BID #48-18 Route 33 Recreation Field
ADDENDUM #2

Issued: March 26, 2018

This Addendum forms part of the original document marked “*Bid 48-18 Route 33 Recreation Field*”.

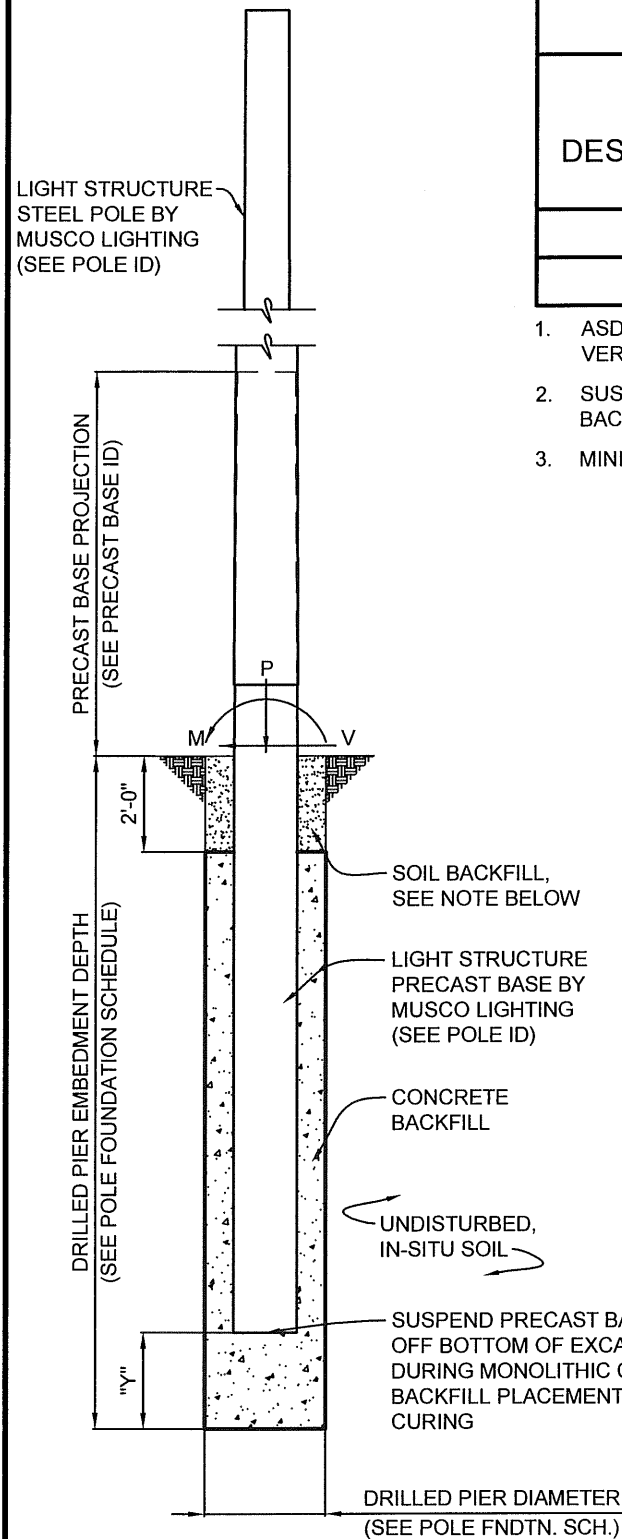
Q: Is there a geotextile fabric required between the permavoid product and turf carpet?

Q: Is there a geotextile fabric required between the permavoid product and drainage stone?

A: **Refer to Drawings**

A: **Refer to Drawings**

DRAWING TITLE: POLE AND FOUNDATION	DRAWING NUMBER C1
SCALE: SEE PLAN	PROJECT NUMBER 183762
NOTES: SCAN #183762A	DATE 18 JANUARY 2018
	DRAWING NUMBER C1
	OF TWO

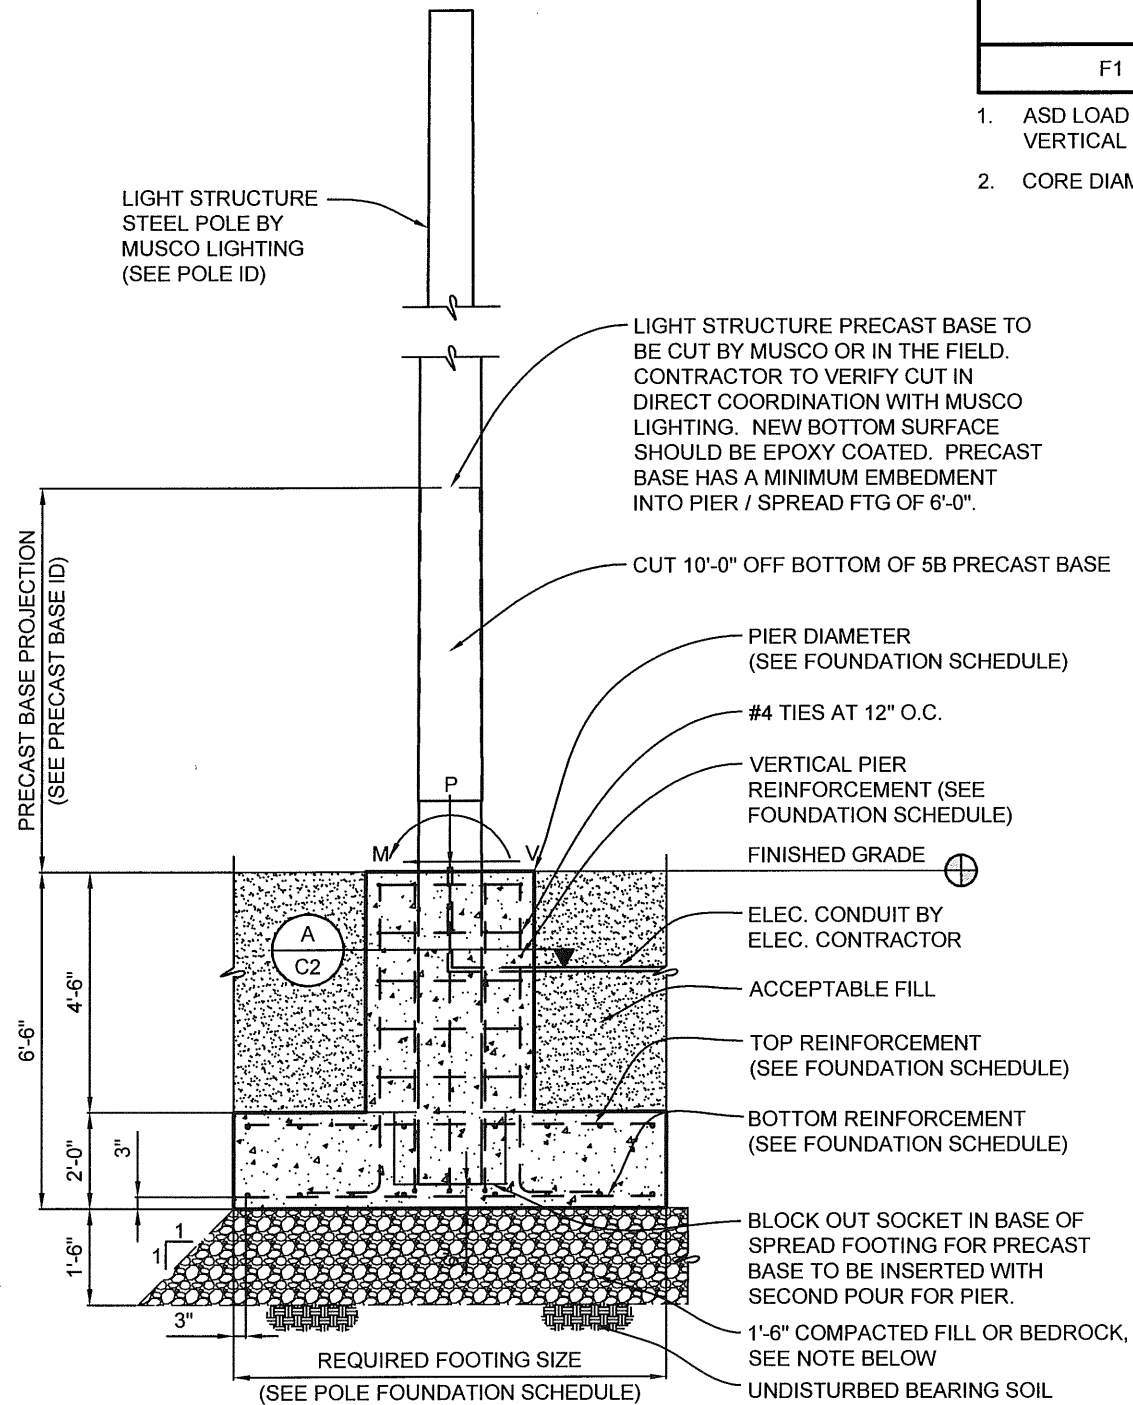
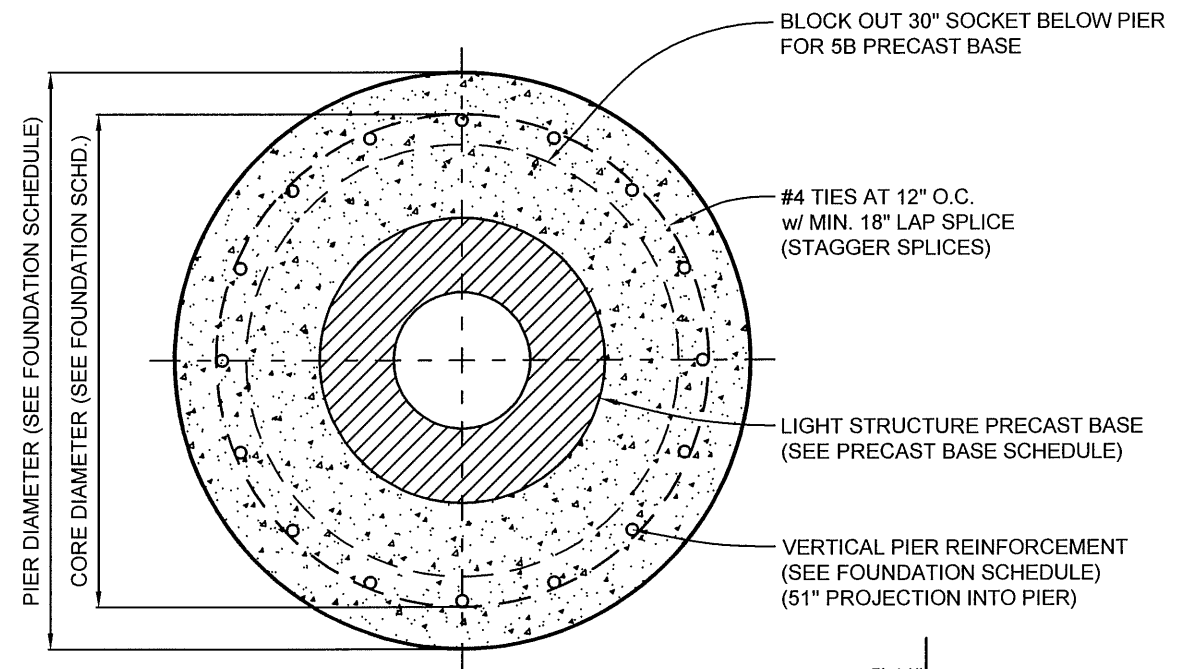
ADD #2-3

Add Add sports lighting footing details to the end of Section 26 56 68
(included at the end as part of this addendum)

Q: Do you have a foundation design from Musco?

A: **Refer to ADD #2-3**
